Development Review Committee

Staff Report

Case No:	20-ZONE-0082
Project Name:	Circle K Landscape Plan & Waiver
Location:	404 & 406 Mt. Holly Road
Owner(s):	Macs Convenience Stores LLC, Harold Smith Jr.
Applicant:	Circle K
Jurisdiction:	Louisville Metro
Council District:	13 – Mark Fox
Case Manager:	Dante St. Germain, AICP, Planner II

- **Review** of Landscape Plan to determine compliance with Condition of Approval (21-LANDSCAPE-0025)
- **Waiver** from 5.5.1.A.3.a to omit the required 3-foot masonry wall between parking and the principal street (21-WAIVER-0028)

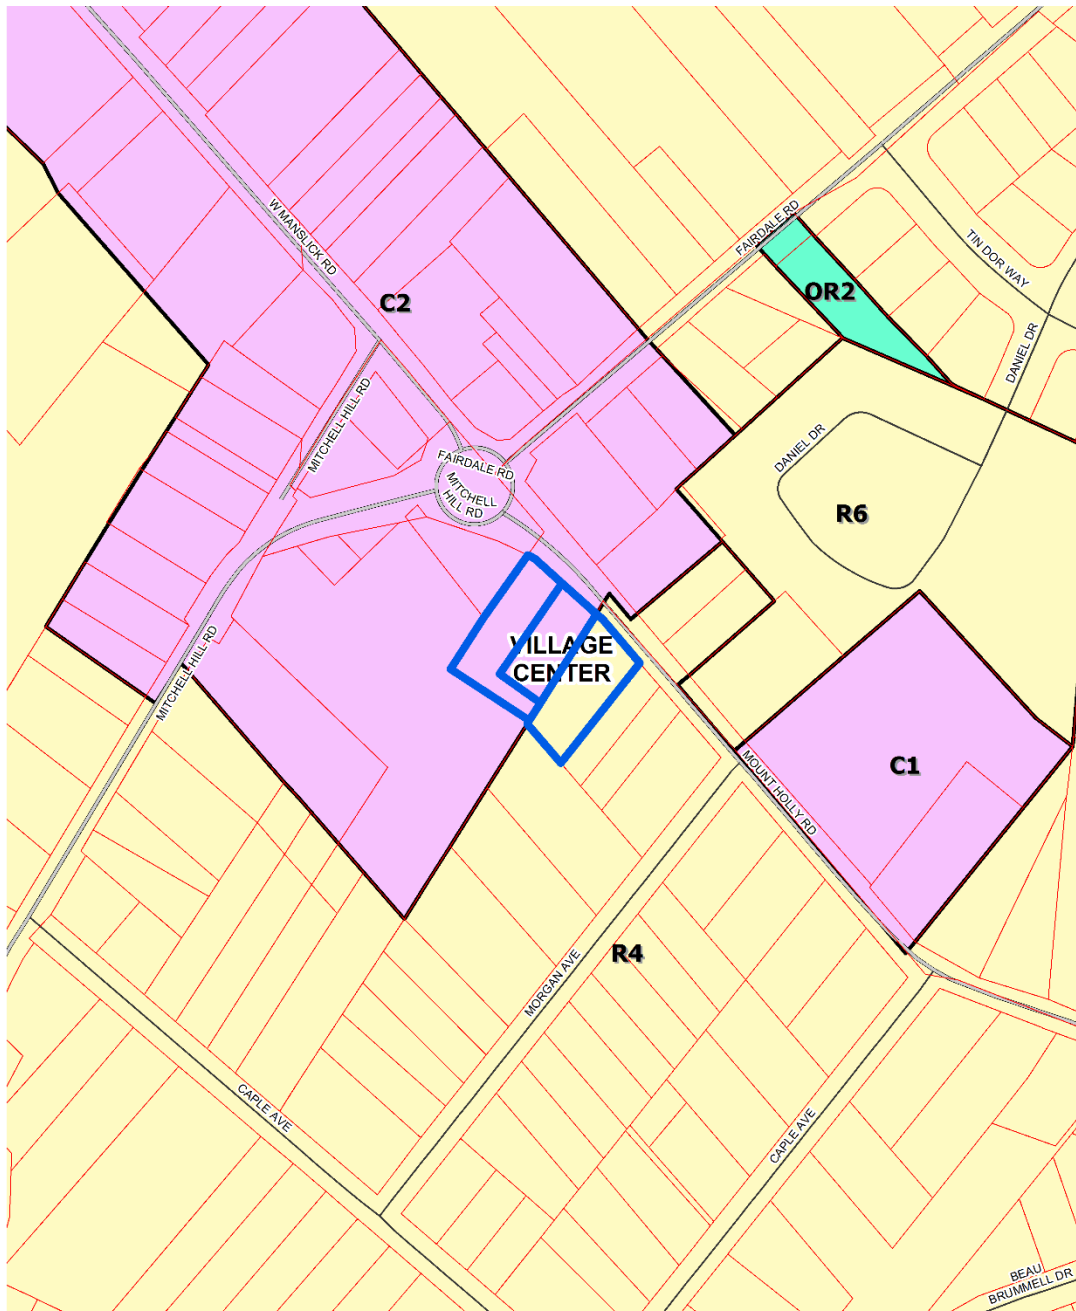
The proposed landscape plan is in compliance with Chapter 10 of the Land Development Code. The Development Review Committee must determine if the plan is in compliance with the condition of approval. Staff finds that the waiver is adequately justified and meets the standard of review provided that the landscape plan is approved.

STAFF: The waiver will not adversely affect adjacent property owners the required wall is between the parking and the principal structure.

STAFF: The waiver will not violate specific guidelines of Plan 2040 as Plan 2040 describes the Village Center form district as comprising a small-scale village center with a mixture of uses, and the Fairdale Village Center Plan encourages a pedestrian-friendly, "Fairdale-feel" site design. Provided that the landscape plan is found to be compliant with the condition of approval, the waiver would be in compliance with Plan 2040.

STAFF: The extent of the waiver of the regulation is the minimum necessary to afford relief to the applicant as the location in front of the property where the wall would normally be placed is being used to provide additional landscaping to comply with the condition of approval.

STAFF: Strict application of the provisions of the regulation would deprive the applicant of the reasonable use of the land or would create an unnecessary hardship on the applicant because it would be difficult to comply with the condition of approval and provide the masonry wall together.
